Burlington Design Advisory Board

DESIGN ADVISORY BOARD Tuesday May 11, 2021 3:00 PM REMOTE MEETING

To: The Design Advisory Board
From: Mary O'Neil, AICP, Principal Planner
RE: ZP21-0799CA, 157-159 South Champlain Street
Date: May 11, 2021

To: The Design Advisory Board
From: Ryan Morrison, Associate Planner
RE: ZP21-0963SP, 278 Main Street (Sketch Plan)
Date: May 11, 2021

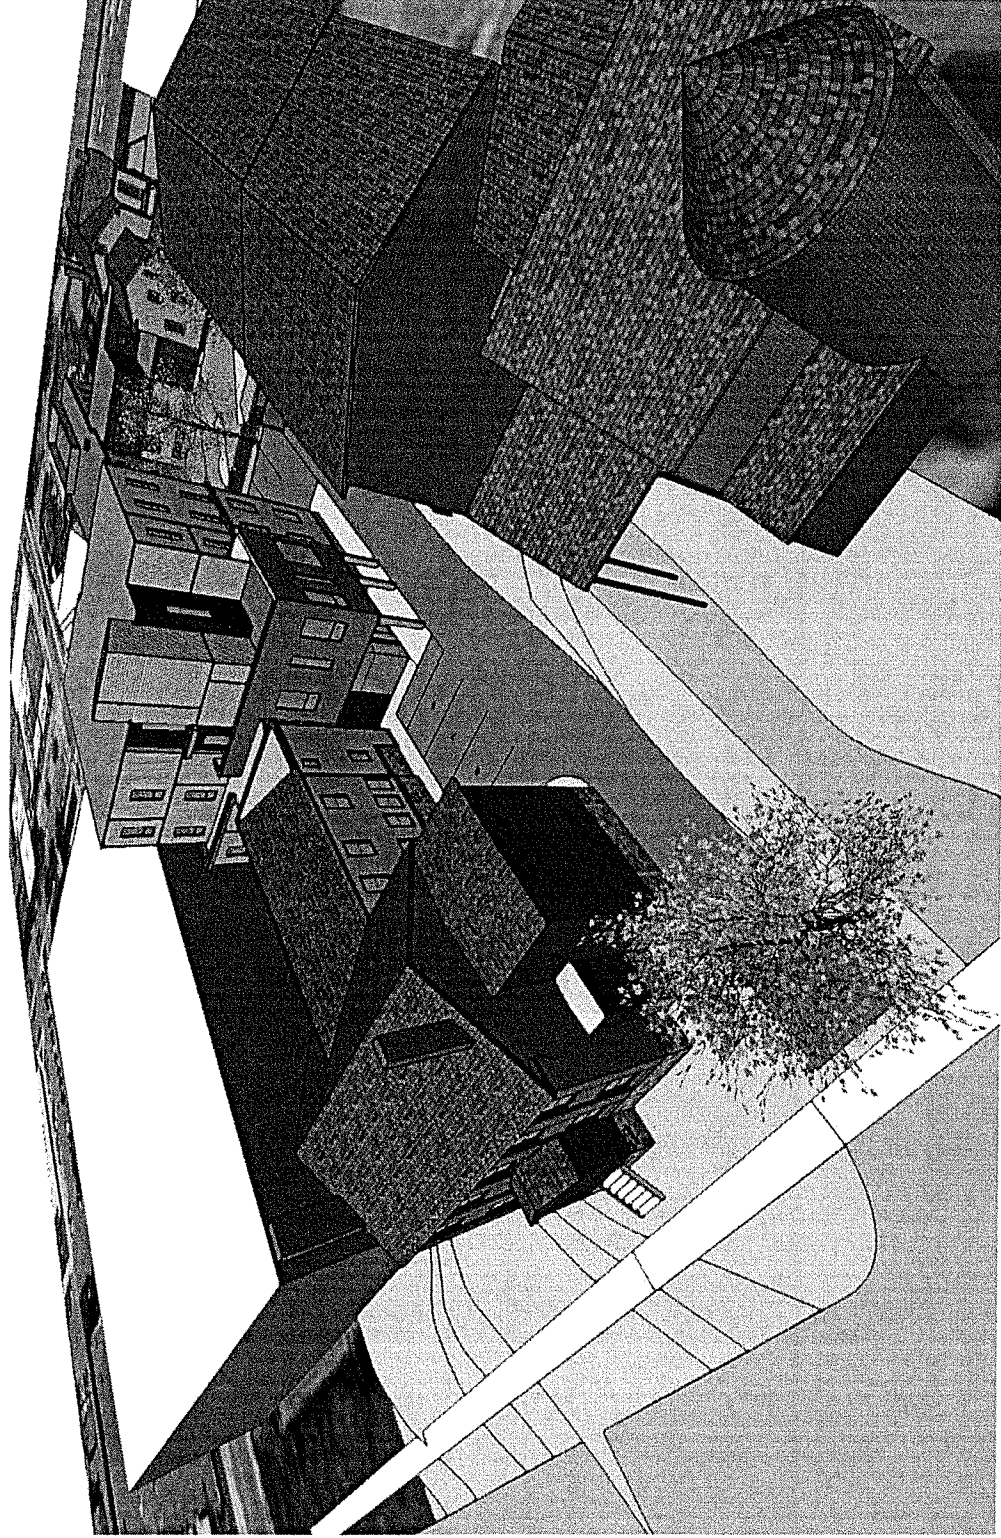
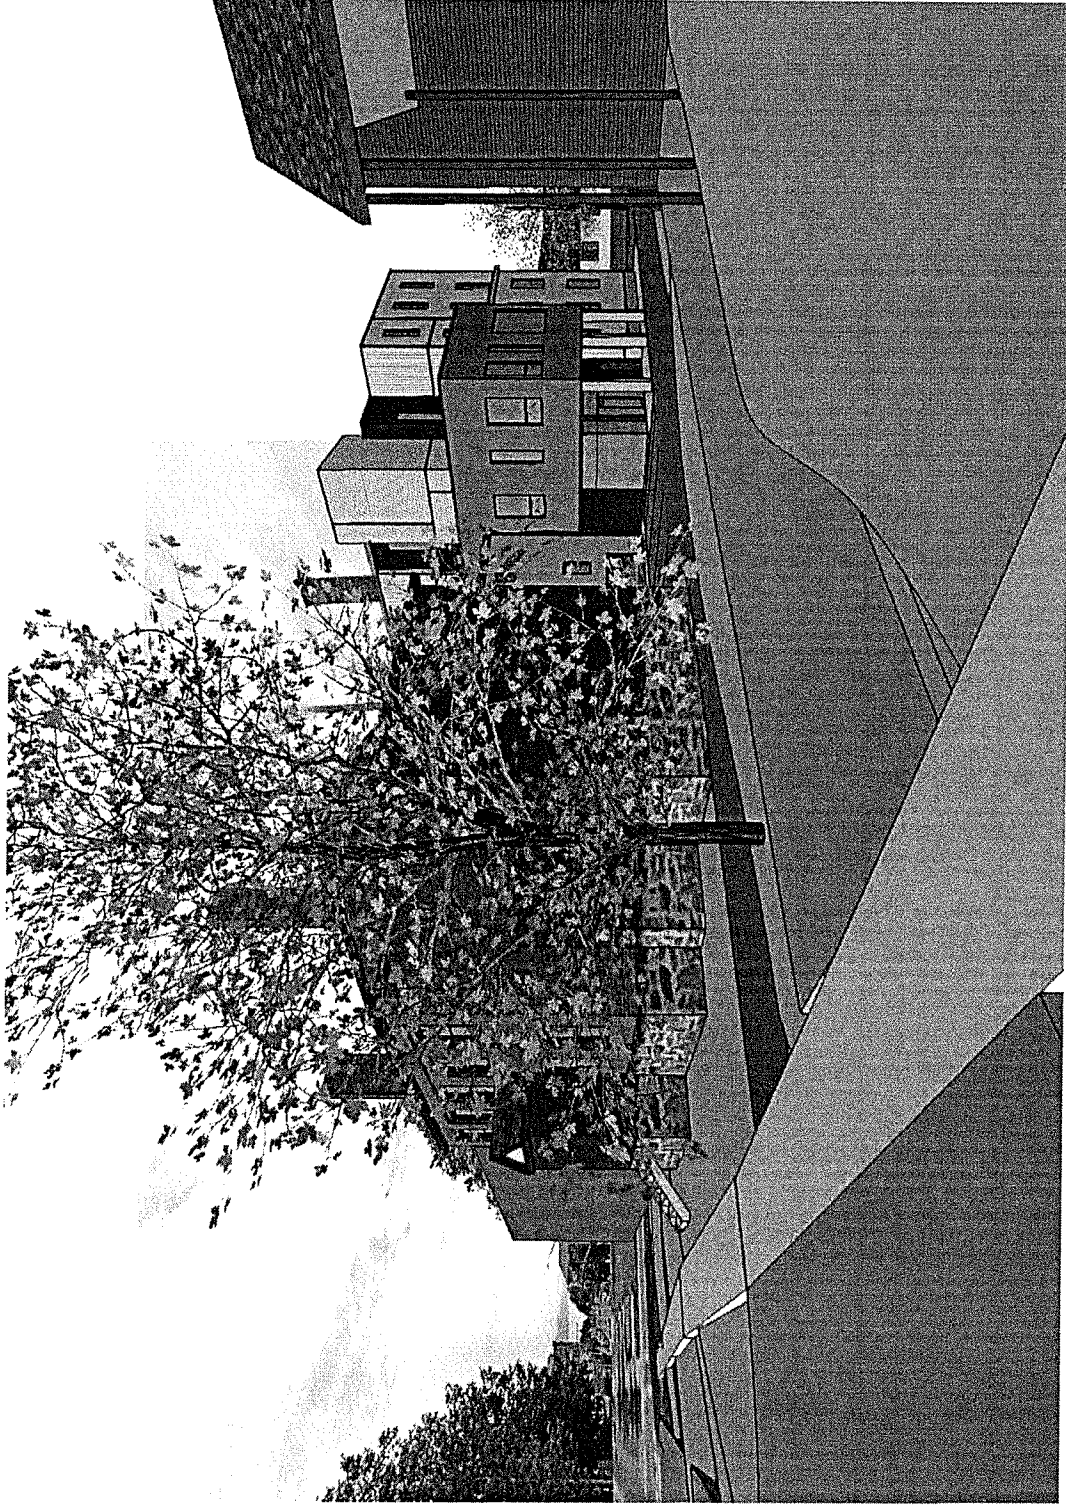
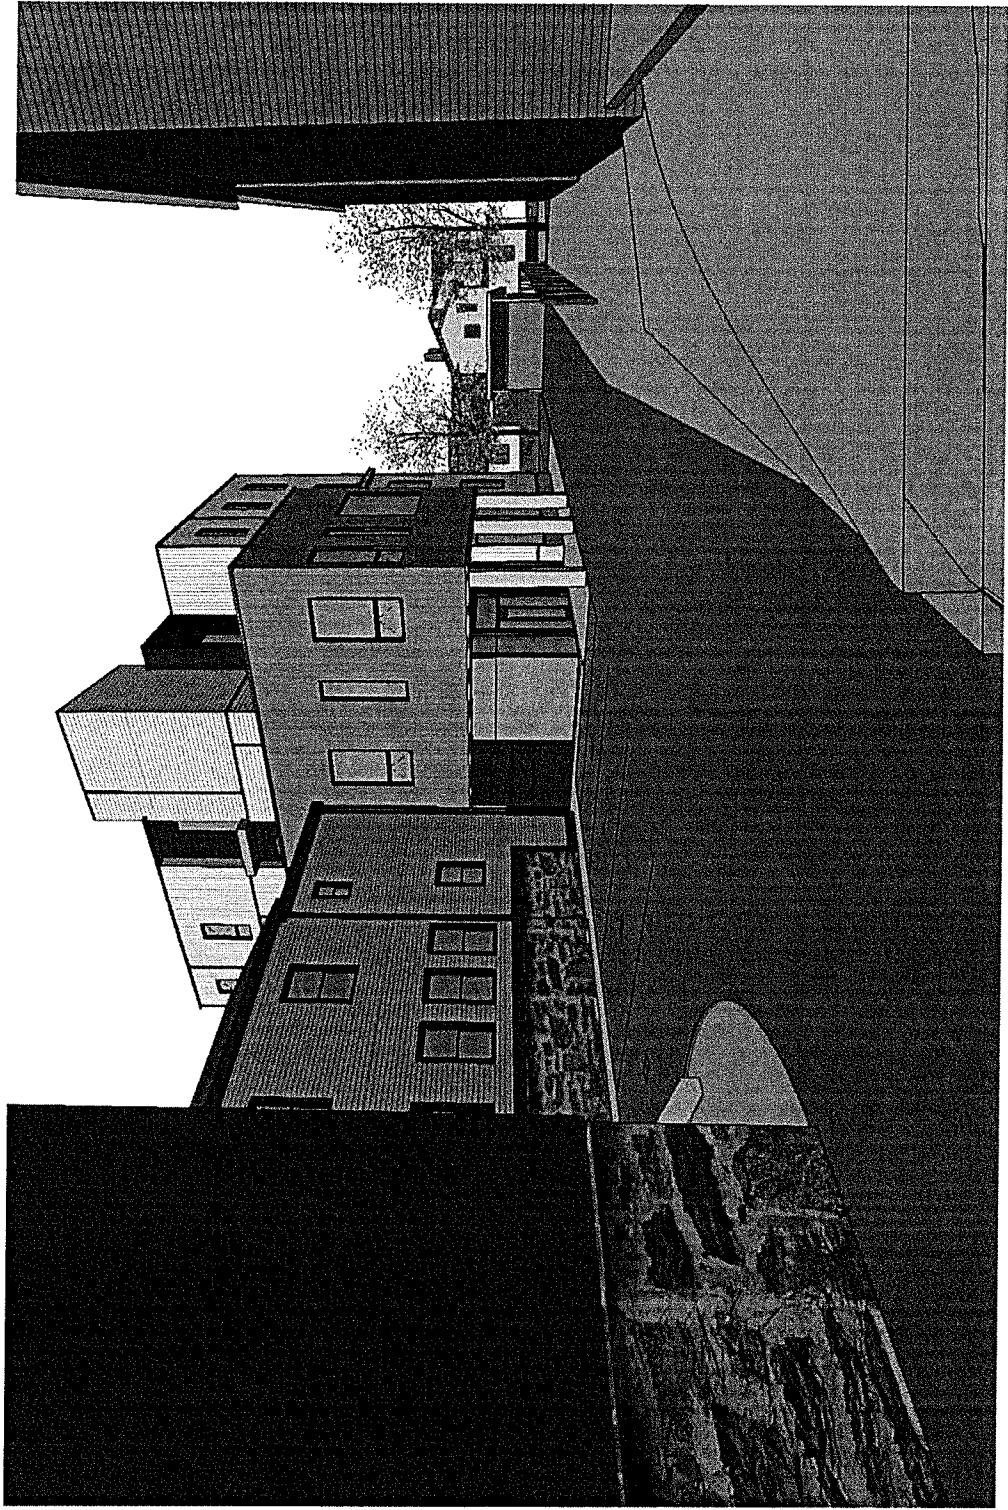
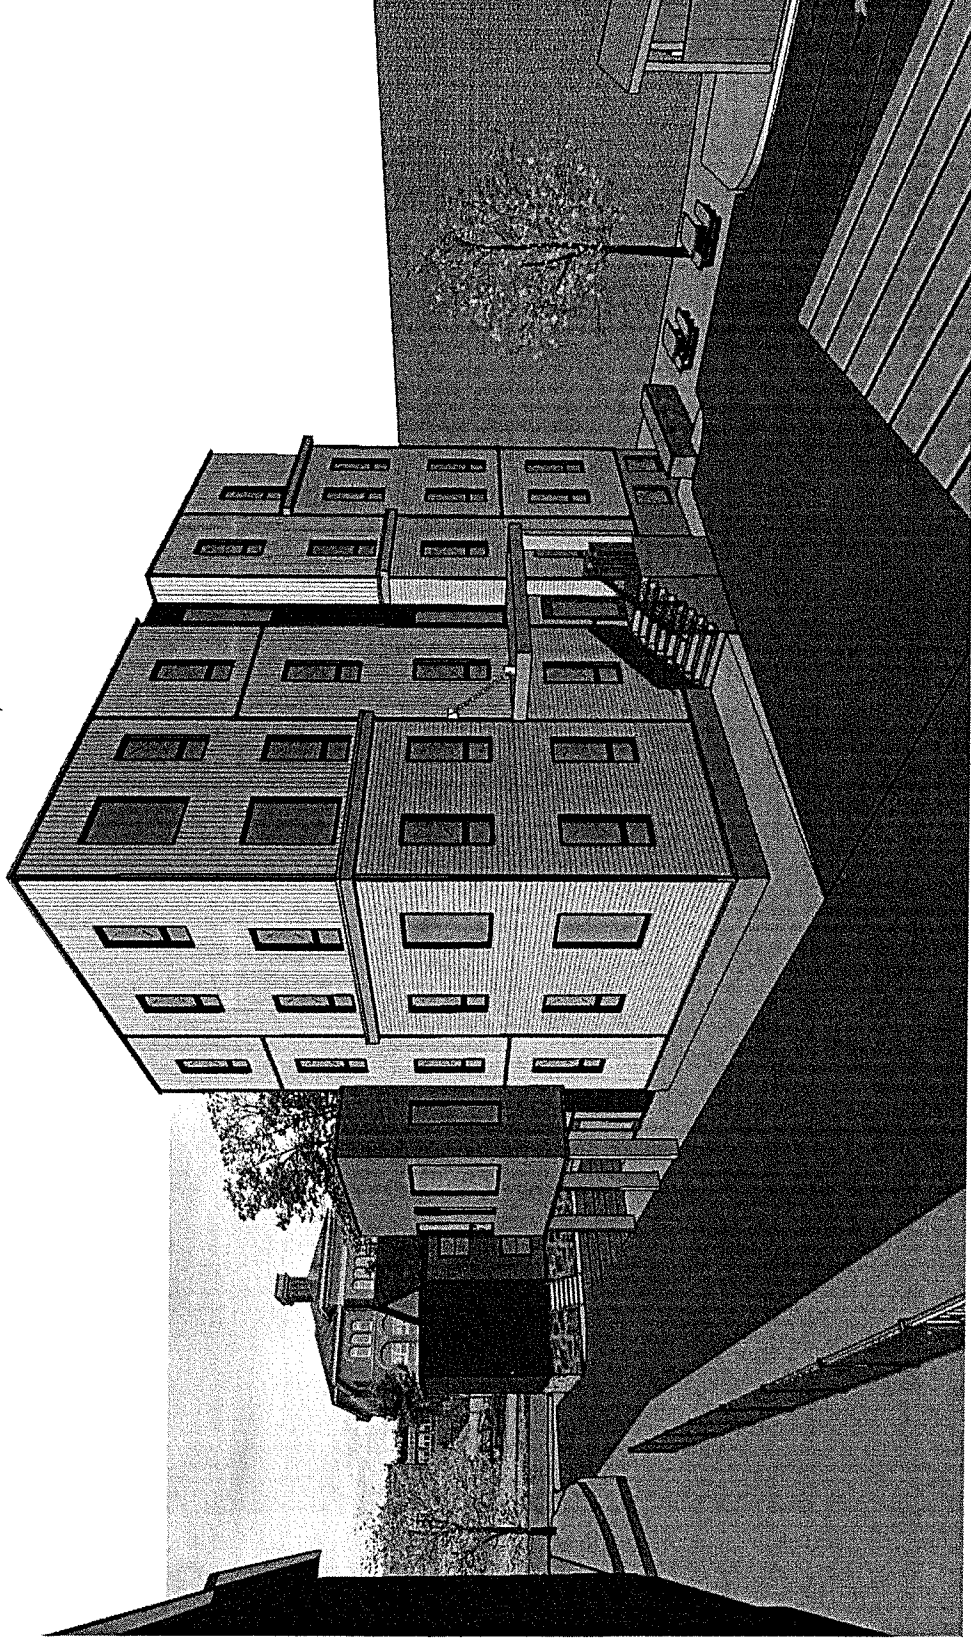
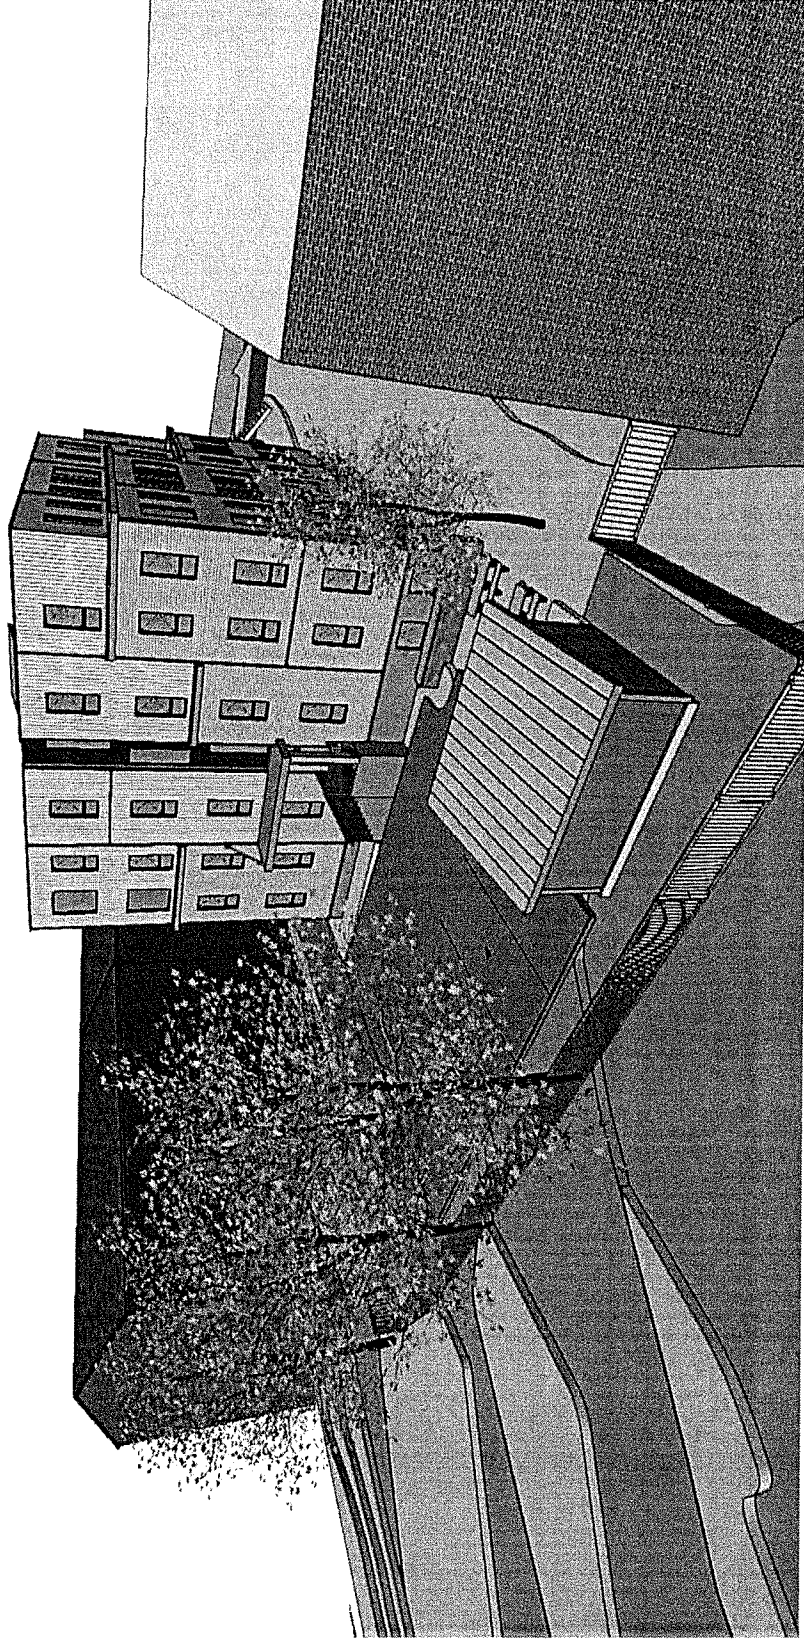
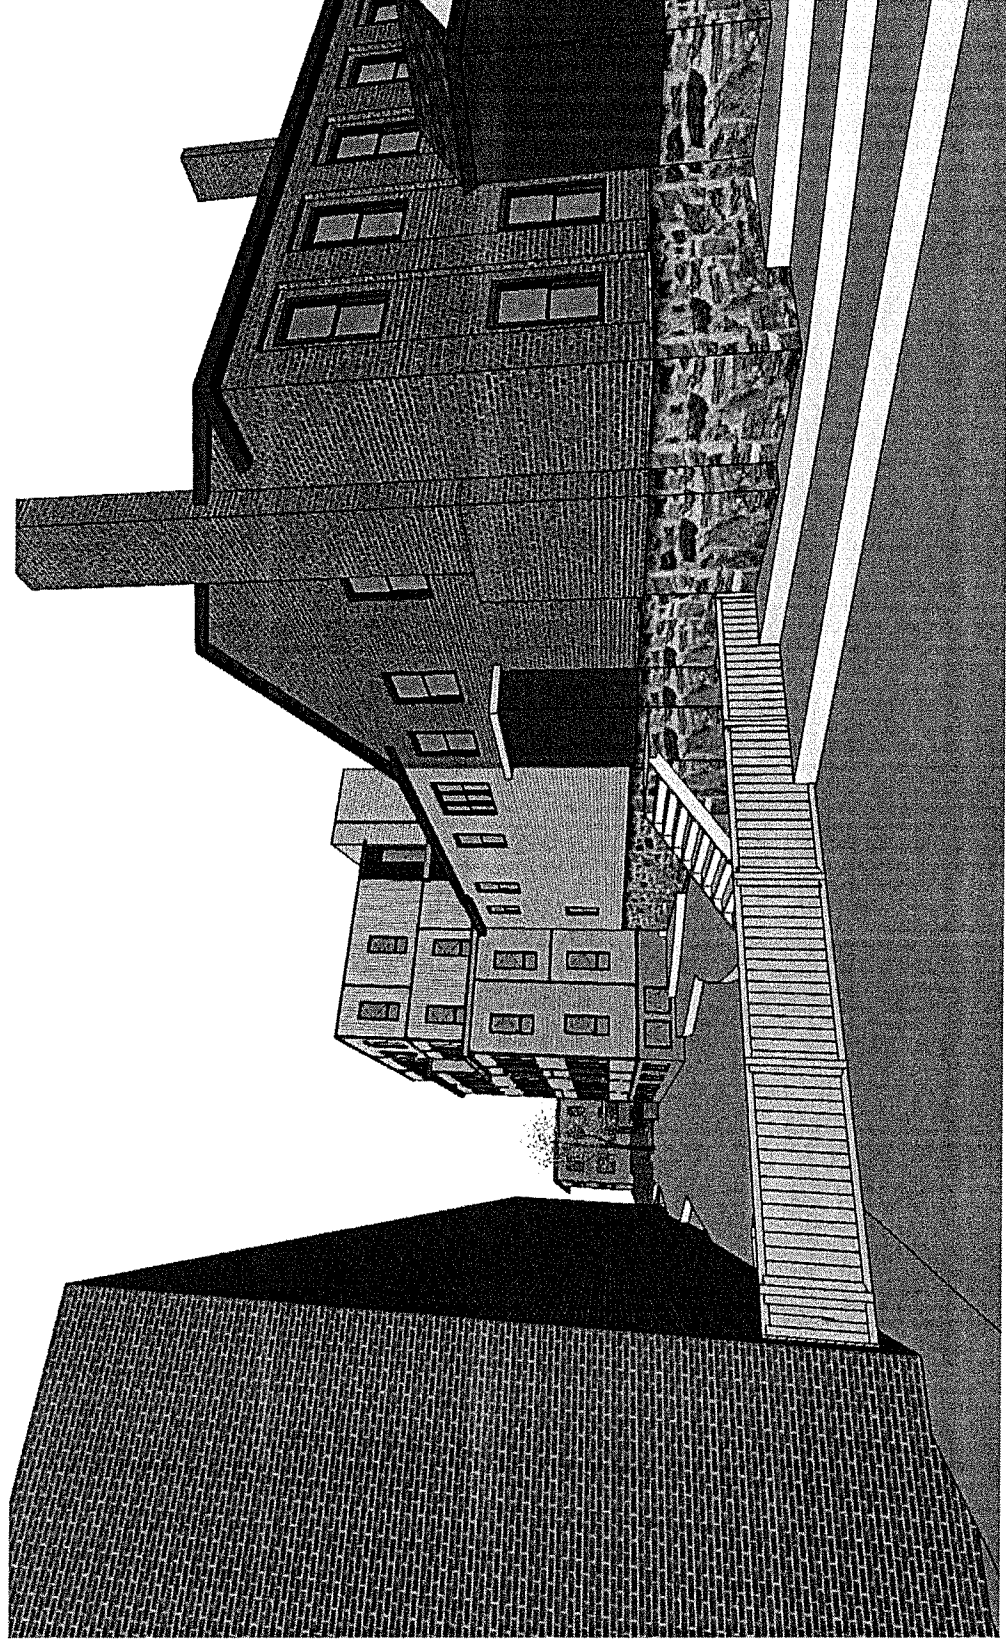
The plans submitted do not reference any exterior lighting. The applicant will need to update the elevation drawings to show where exterior light fixtures will locate, and provide manufacturer's spec sheets of the fixtures to be used. Compliance with the lighting standards of Sec. 5.5.2 will be required.

The elevation drawings show a variety of window types, with fixed, awning and casement windows throughout. With the exception of the elevator tower, there aren't any blank walls. Three first level access doors are provided (east and north side), and there appears to be a door on the south wall that will provide access to a portion of the second floor's rooftop.
